**SUBJECT:** SP21-064; Douglas 234 F6 L2 - Car Wash  
Review Comments 01

# CARWASH SITE PLAN

**SITE PLAN LOT 2**

**CAR WASH**

**COVER SHEET**

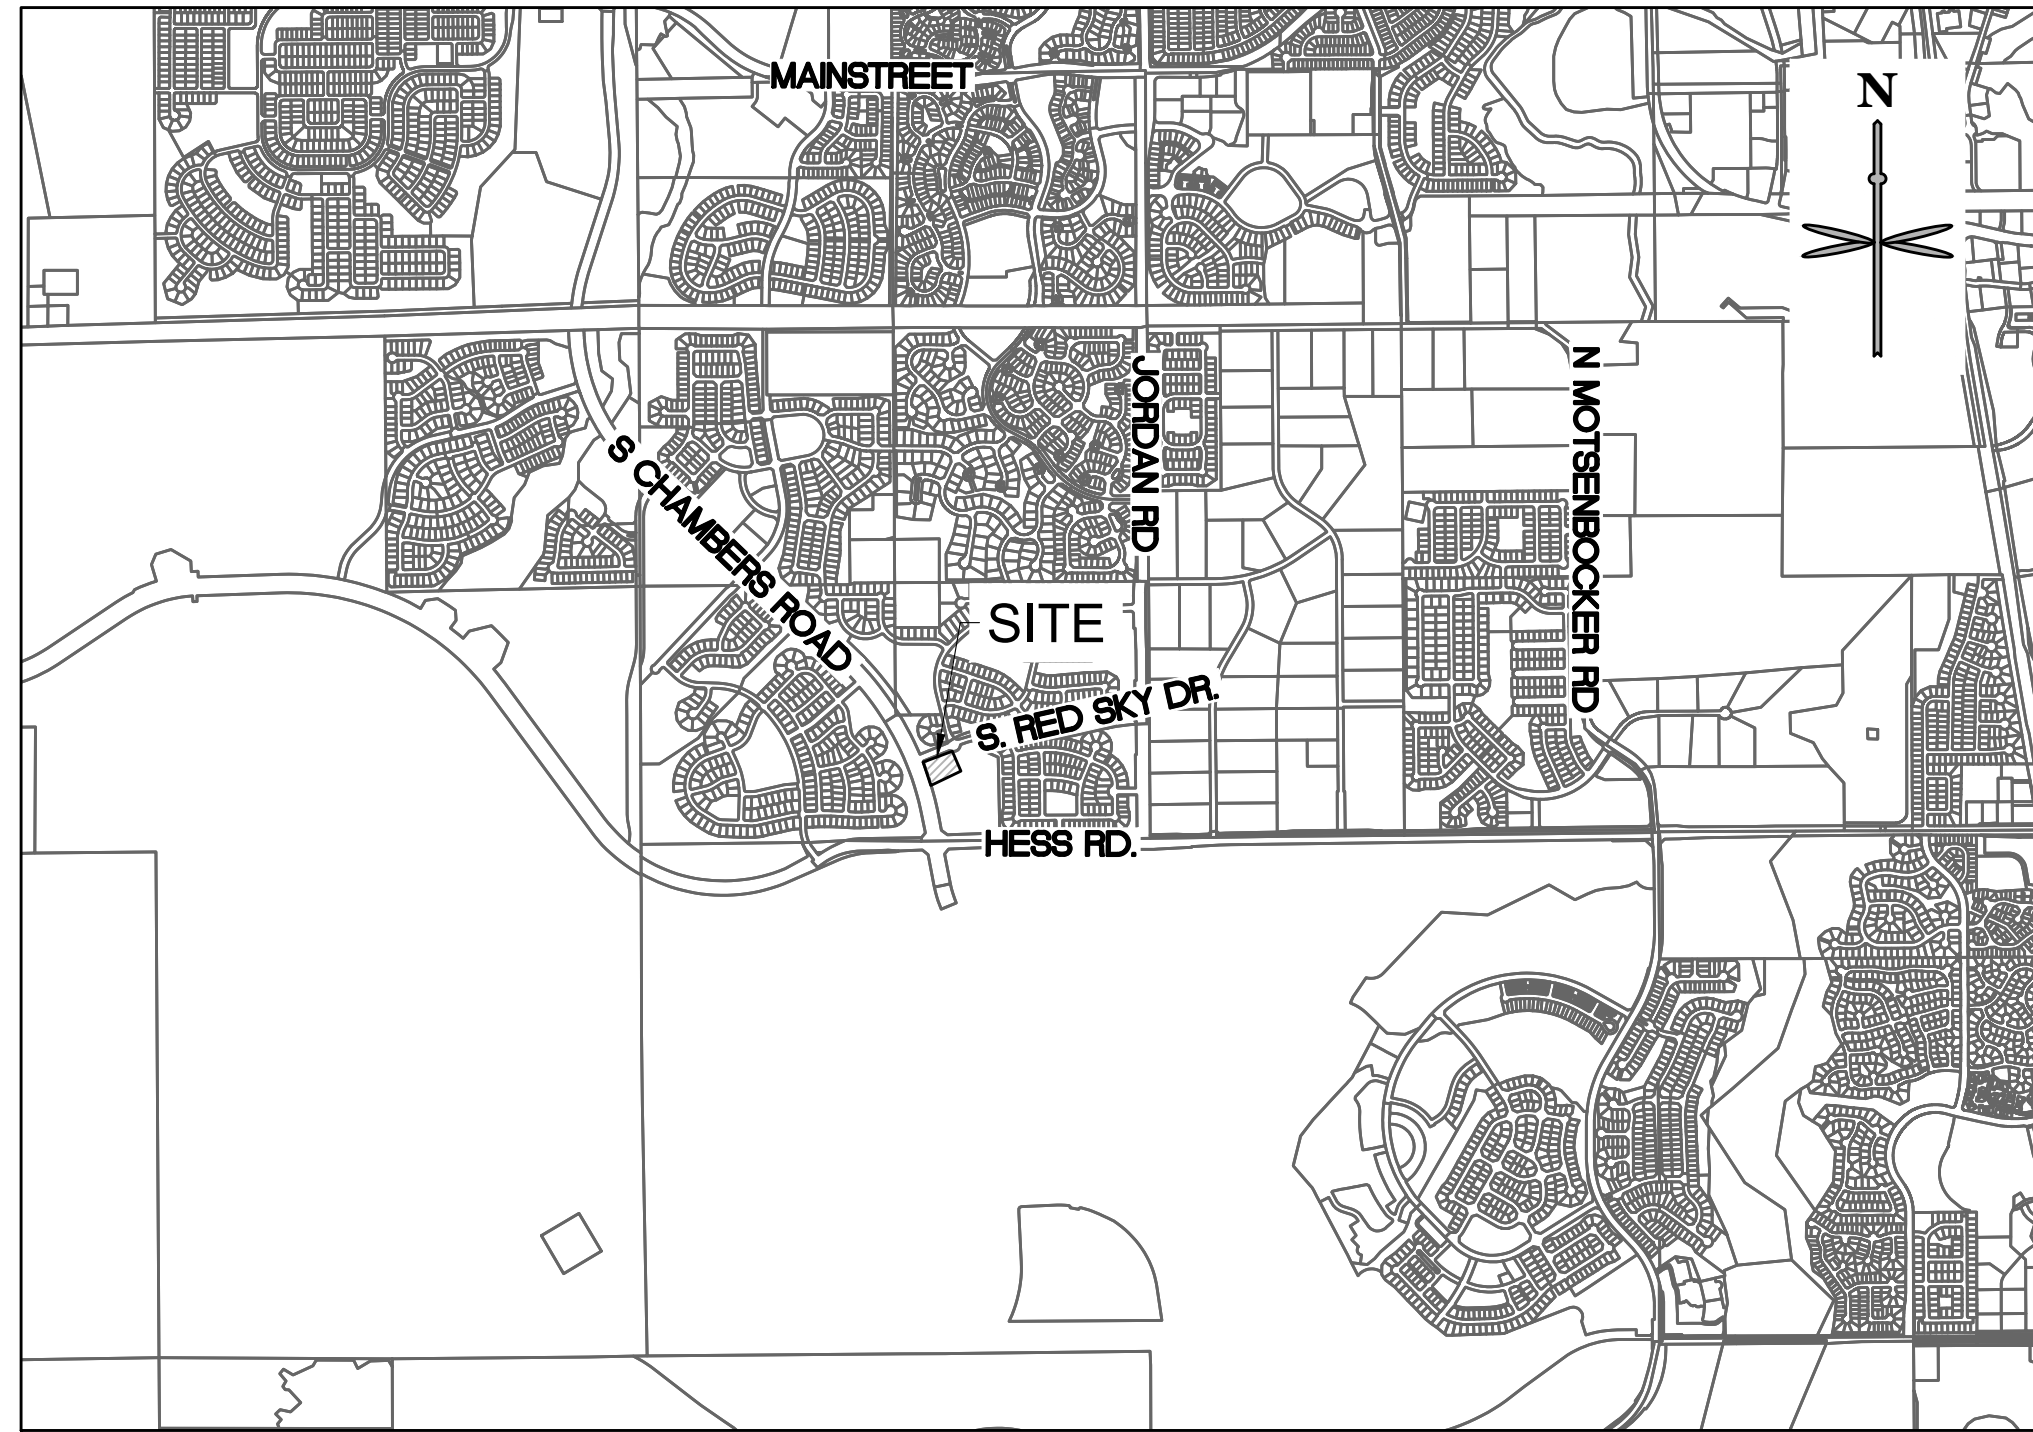
The Legal Description needs to be the main title-switch 1st and 2nd lines

what is labeled side is actually front, revise

what is labeled rear is actually side-please revise

Max FAR is 50%, where are you getting 25%?  
<http://parkeronline.org/DocumentCenter/View/22897/52---Douglas-234?bidId=>

You still meet requirements but please revise max to 50

North & south property lines are side yards

East is Front  
West is Rear

Rear and Front face ROW and require 25'

North side and south property line require 10'

Revise to show accurate required vs. actual

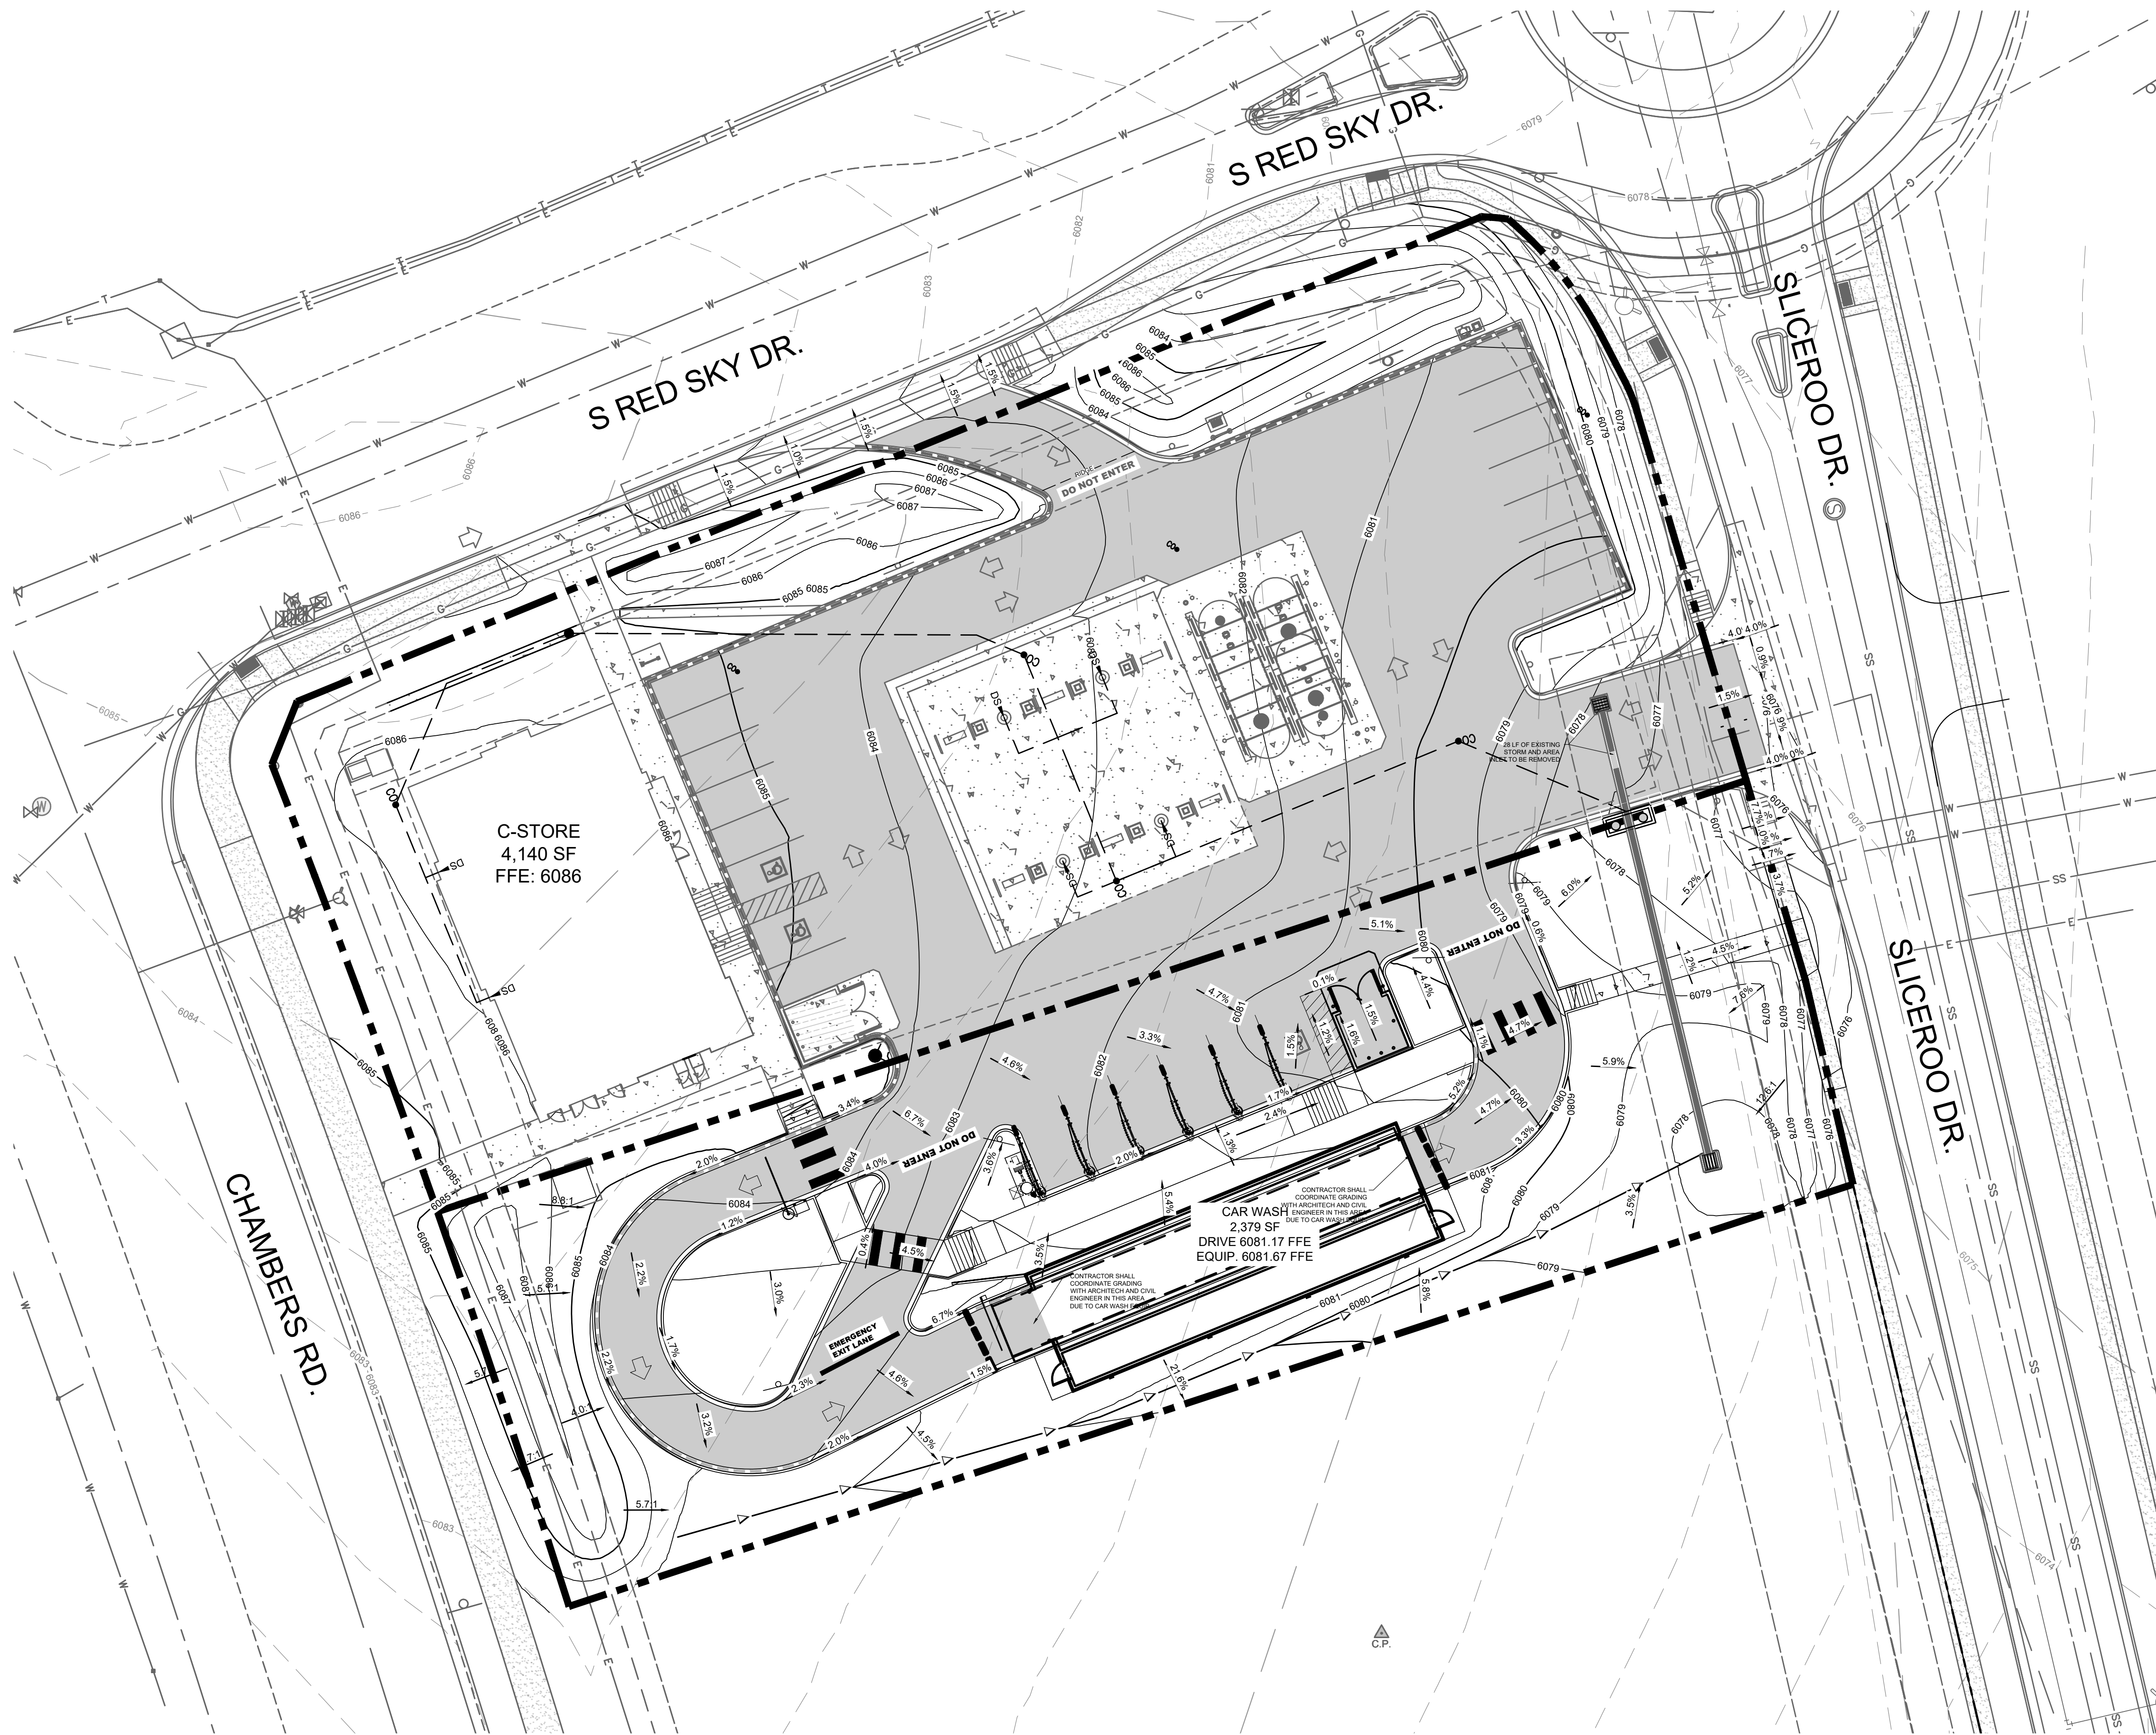
How are you screening this drive aisle from the ROW per Design Standards: Vacuum stations and finishing areas shall be located away from open space and residential land uses and shall be screened from view from a public roadway using enhanced landscaping with an 80% opacity and/or a screening wall.

Remove all references to required building setbacks and reference and dimension actually setback to building lines.

Must be minimum 10 foot setback to property line.

Please dimension all building lengths and widths.

How are you screening the tunnel opening from ROW-required by design standard.

## 1 LANDSCAPE PLAN

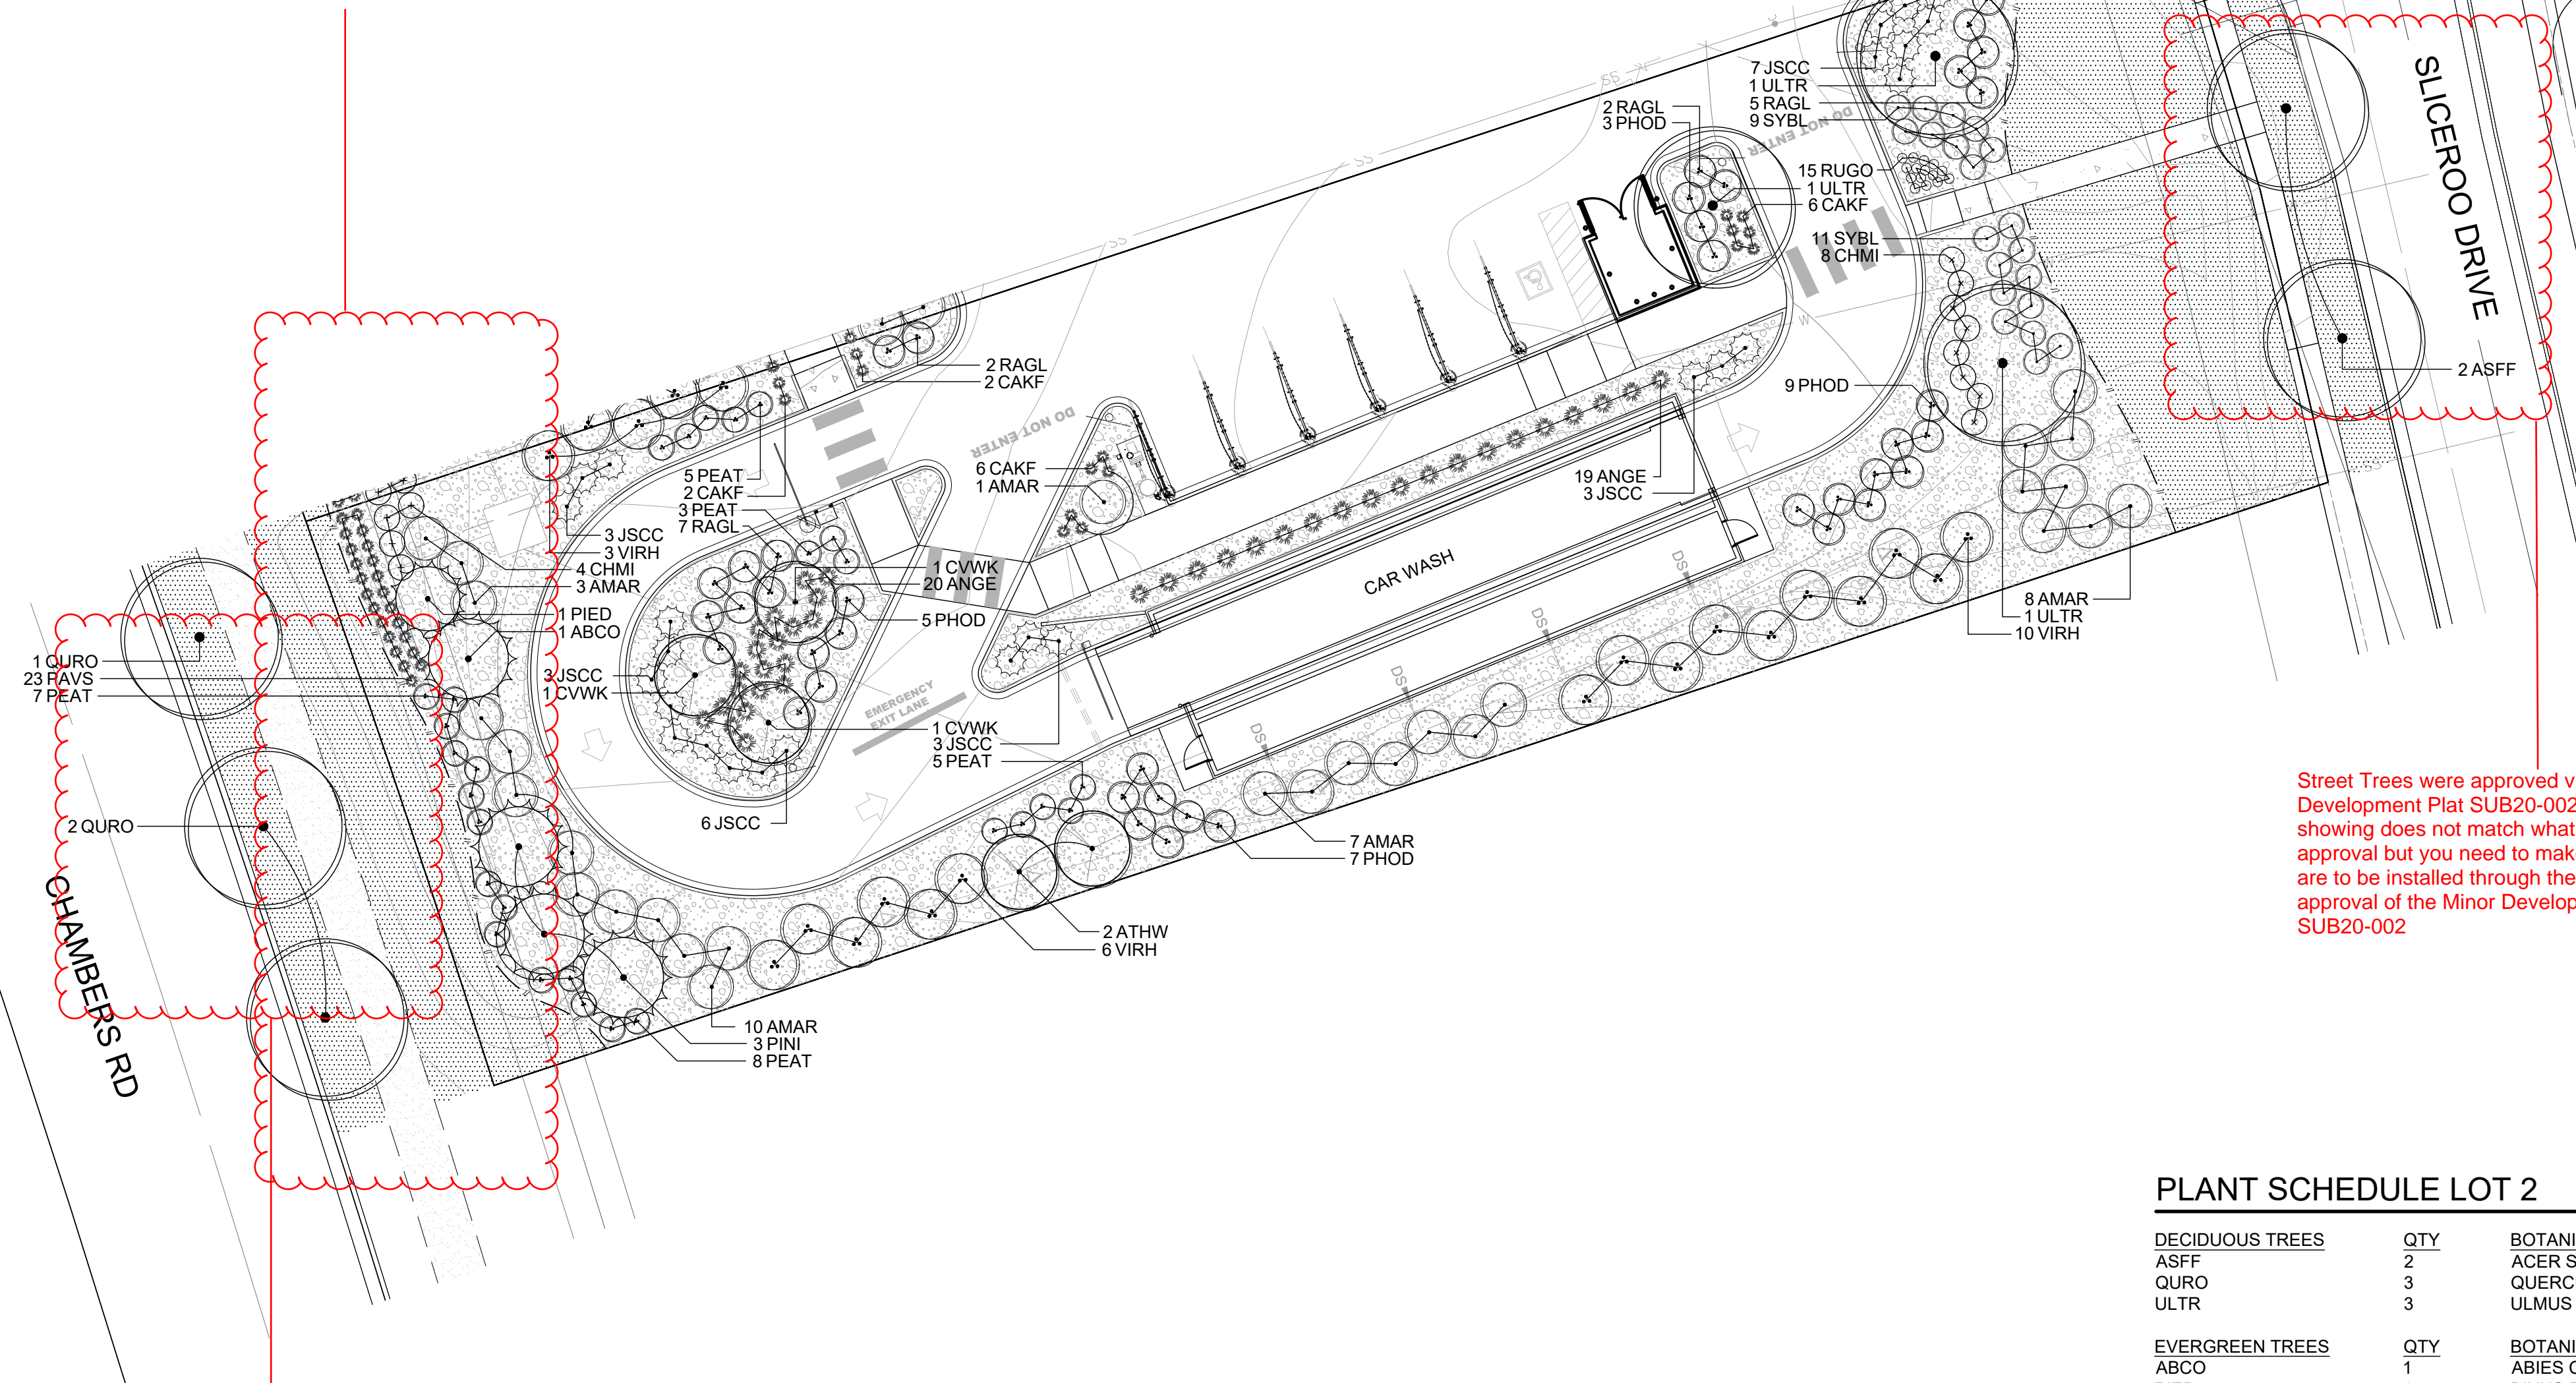
The Enhanced Landscape Perimeter ratios should be used (tree requirement: 1/40 L.F. and shrubs: 5/40 L.F.) along all rights-of-way: Red Sky Dr., Chambers road, and Sliceroo Dr.

Street Trees were approved via Minor Development Plat SUB20-002. What you are showing does not match what was approved in that approval but you need to make a note that these are to be installed through the Agreement and approval of the Minor Development Plat SUB20-002

Include Maturation Heights

Traditional turf grasses shall only make up fifteen percent (15%) of any required on-site landscaping for commercial and industrial uses. You need to show the Percentage and compliance.

1. Call out lot size to show how you get 15%
2. Break out the required Streetscape Landscaping-no further that 1 tree ever 40' apart
3. Need to break out Parking Lot Perimeter Landscaping
4. See example chart provided on referral notes.
5. Math needs to be shown for all calcs. of how you get to the required percentages
